### ADDENDUM NO. 2 November 14, 2023

### Burnet City Hall – RFP 2023-012 PID: CIPSP-2022B

This Addendum forms a part of the Contract and clarifies, corrects or modifies the original Construction Documents, plans dated <u>9/15/2023</u>. Acknowledge receipt of this addendum in space provided on Proposal. Failure to do so may subject bidder to disqualification.

PROJECT NO. 2021-16 WINDOW OPENING TYPES | SCHEDULES A1.4

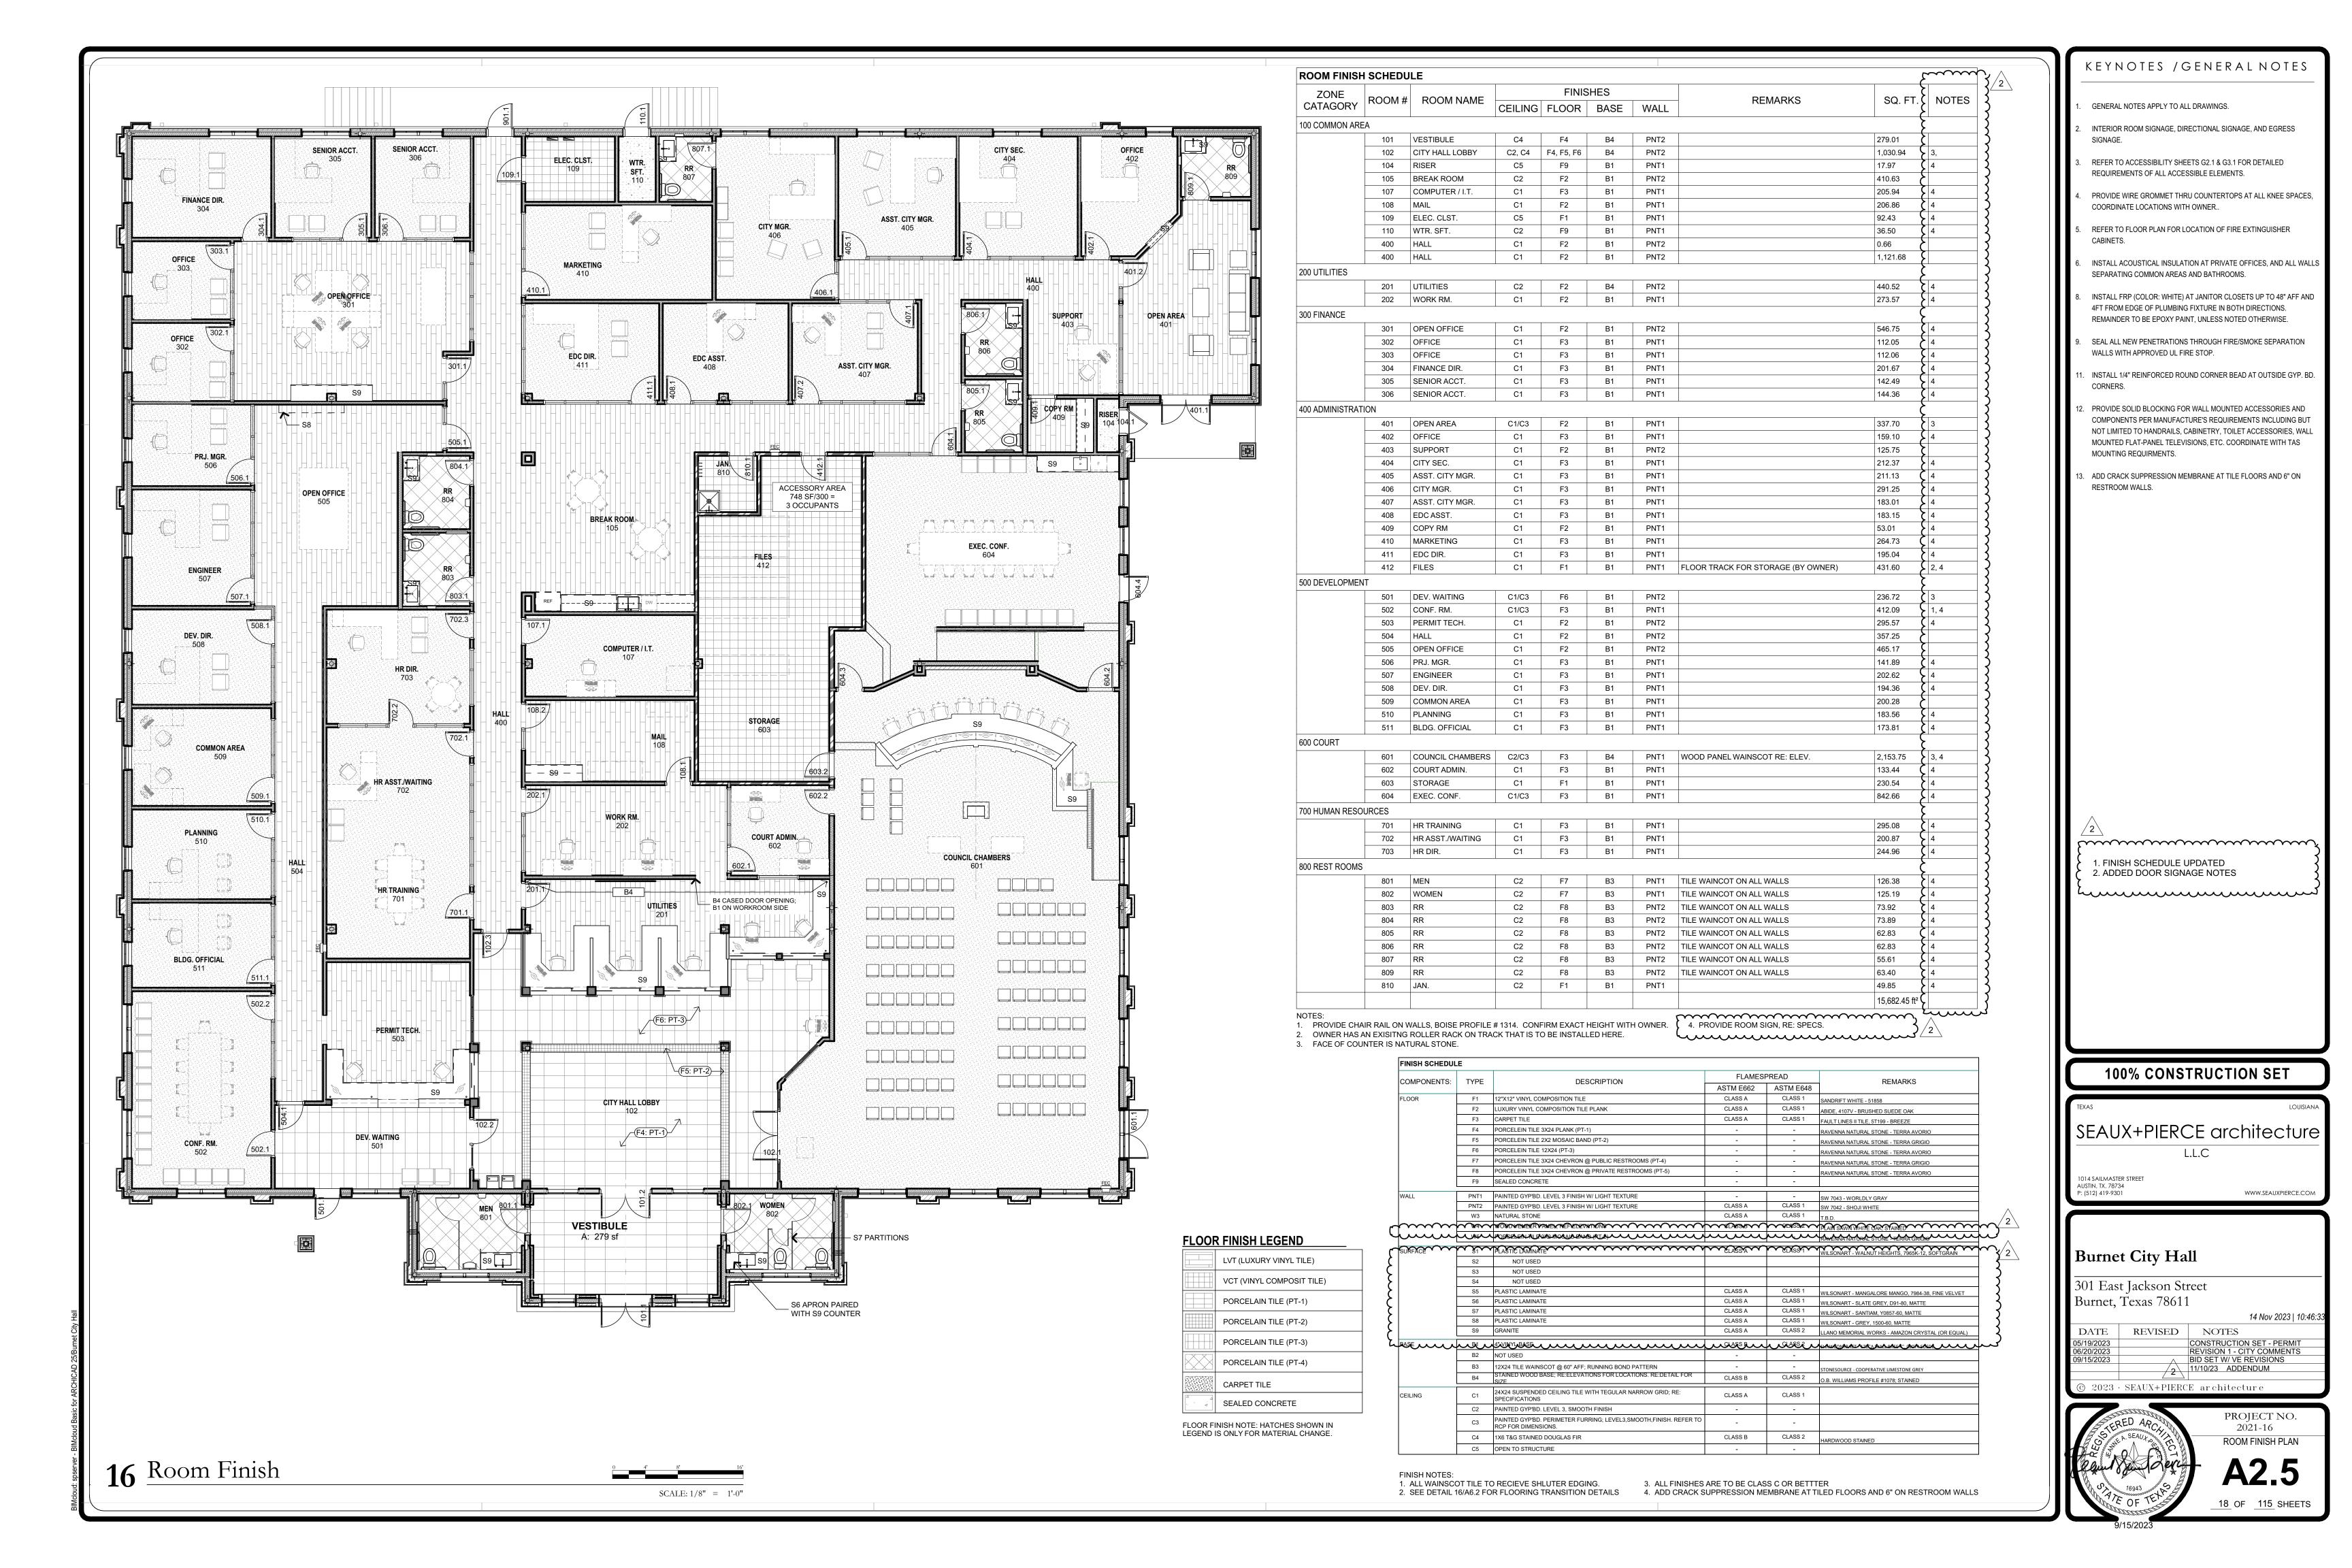
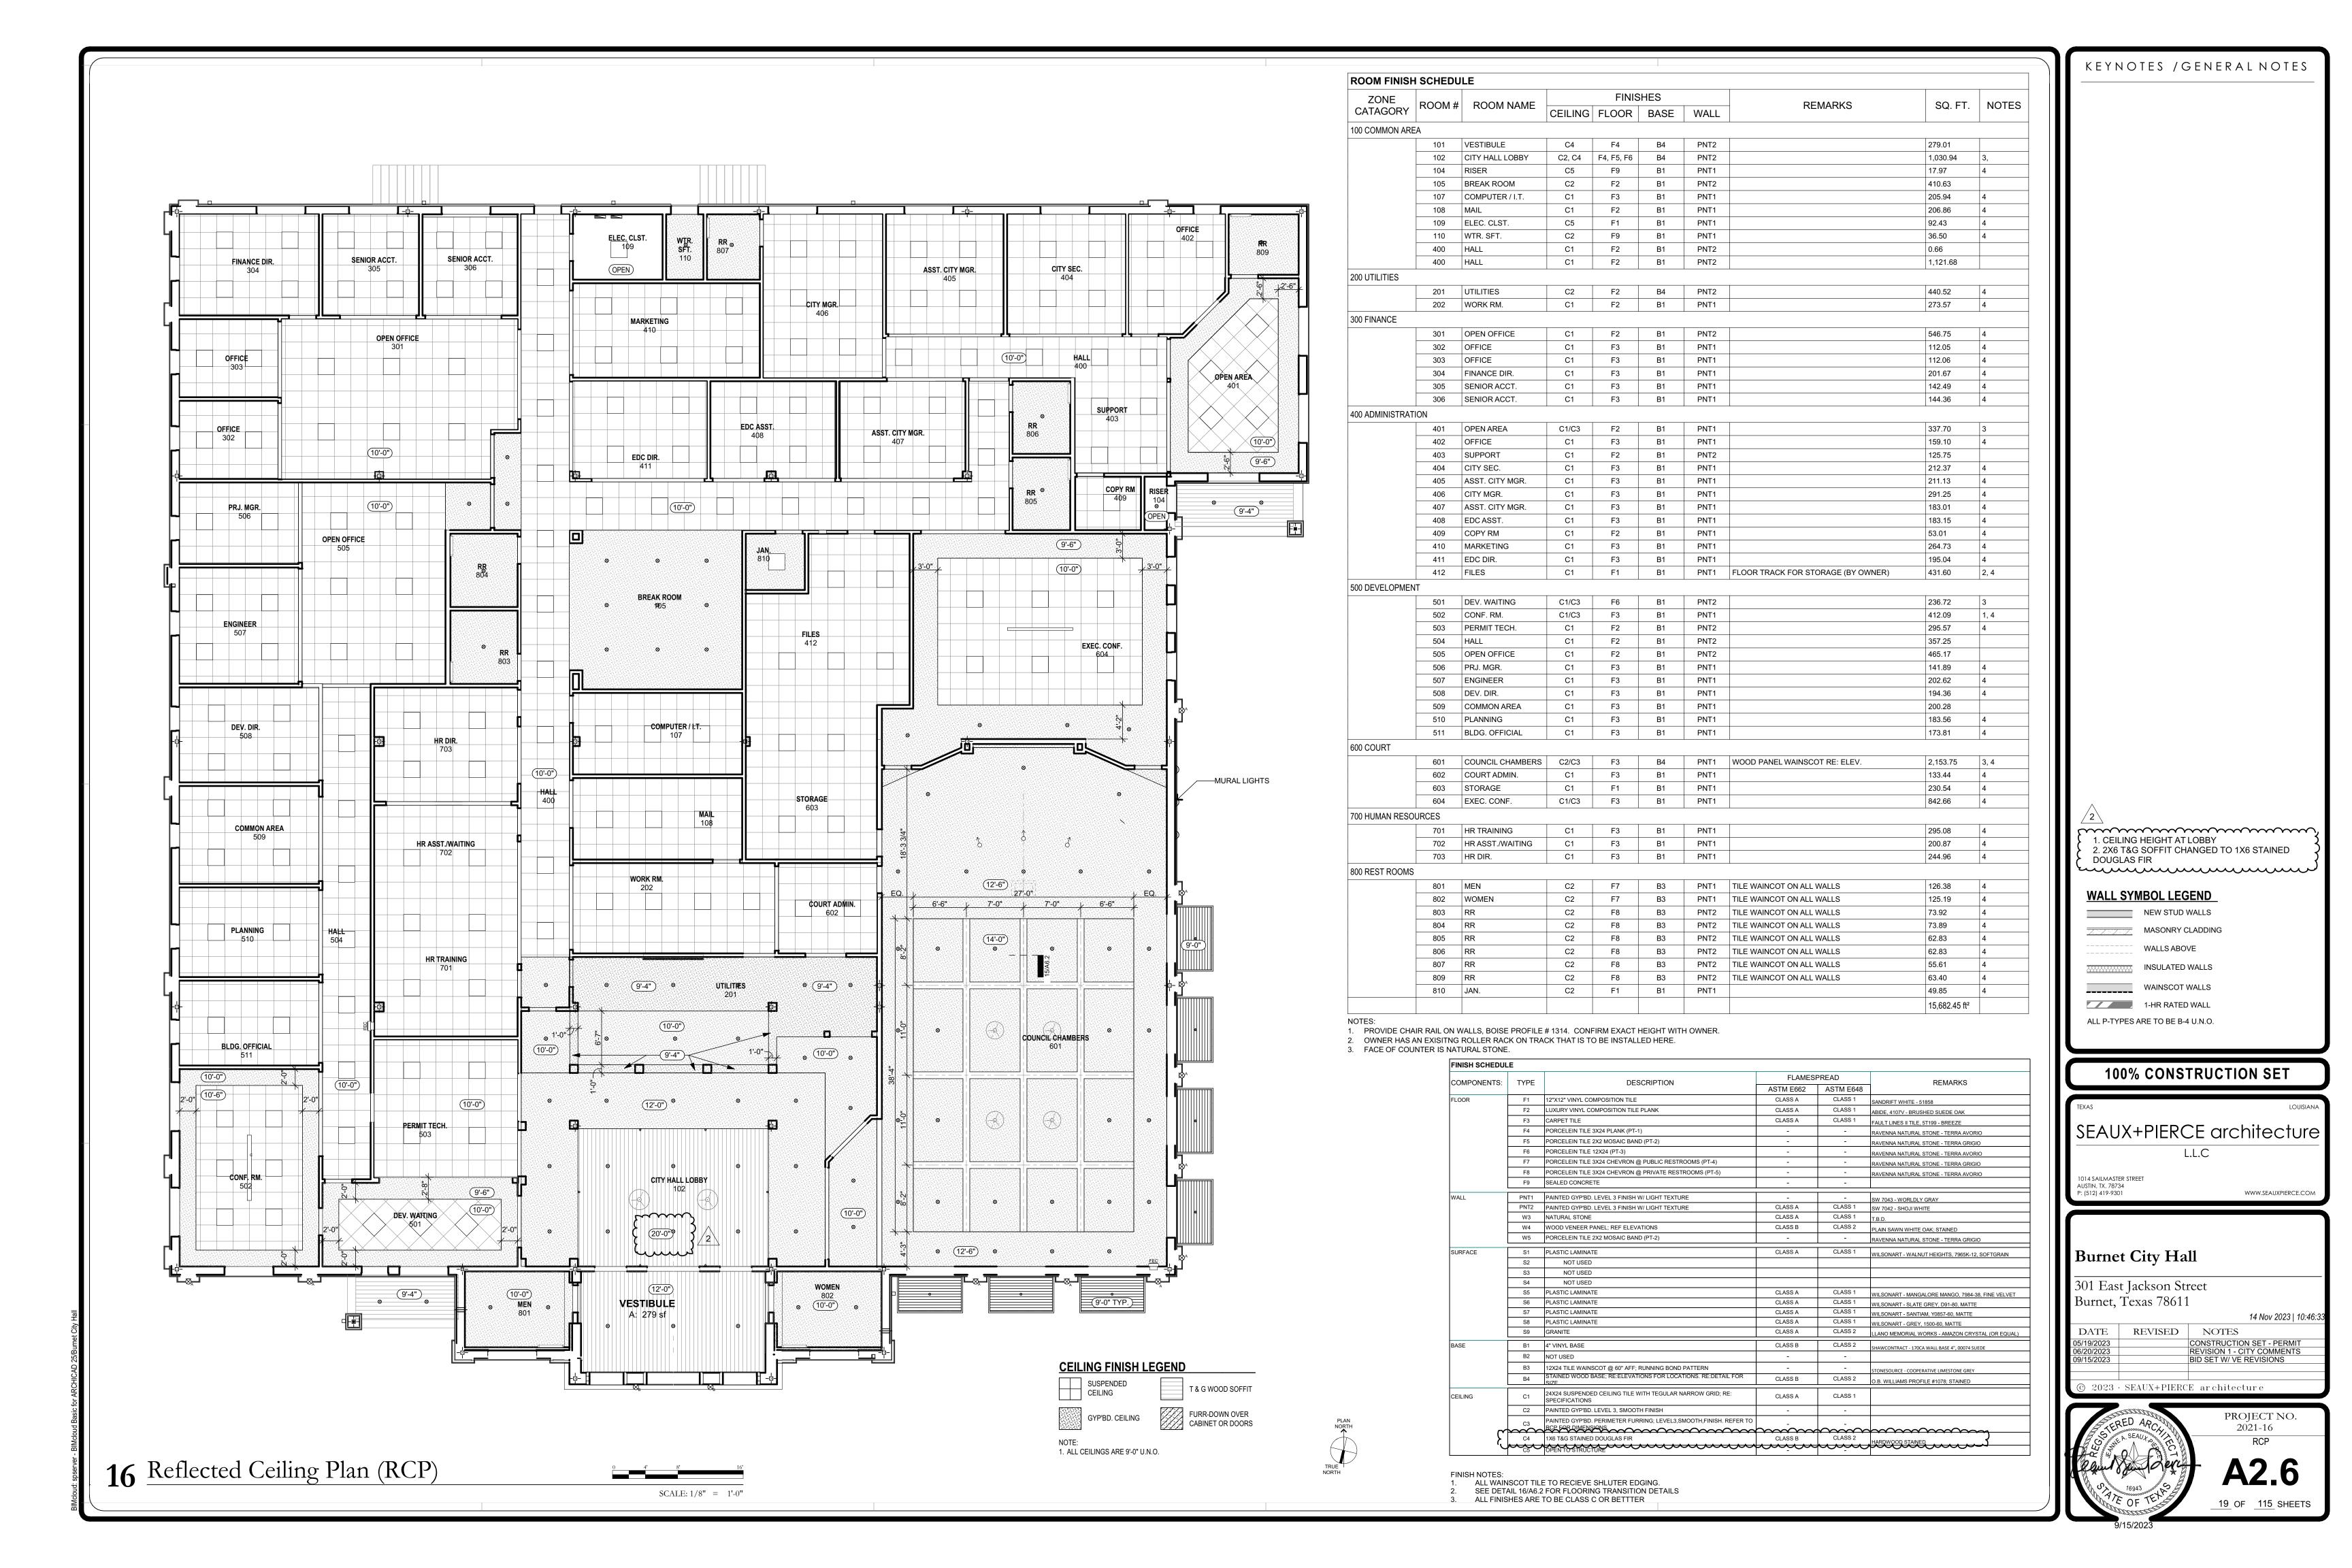
- 7. Sheet A1.4 (Window Schedule)
  - a. Changed size of window type WH and adjusted head height.
- 8. Sheet A2.3 (Roof Plan)
  - a. Changed roofing to PVC Membrane system.
